I am writing in relation to application 2016/2313/P, details required by condition 21 (ground investigation) of planning permission 2013/5947/P dated 18/06/14 and variation 2015/3151/P dated July 2015 for the redevelopment of the Greenwood Centre. The application states that you gave pre-application advice in March.

I am concerned with (a) the adequacy of information provided (b) the relevance and importance in support of Condition 24 which requires a full archaeological evaluation and Council-approved report before ground works commence.

Camden geography (1931)

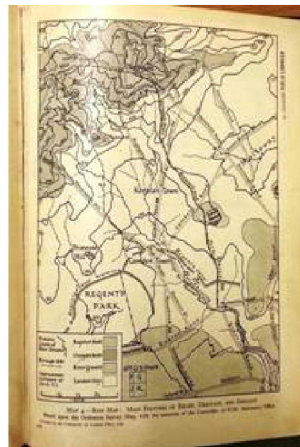
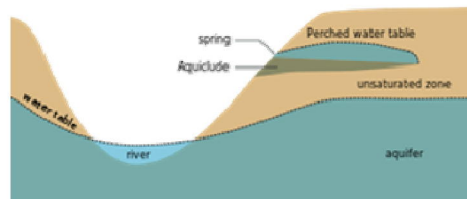
Dr Elizabeth Cooke's 1931 map of Camden's river geography s shows the Highgate branch as the main river, from Highgate hills, not a 'tributary'. It is also unclear why this is only 'perched water' - which would place it in the unsaturated zone:
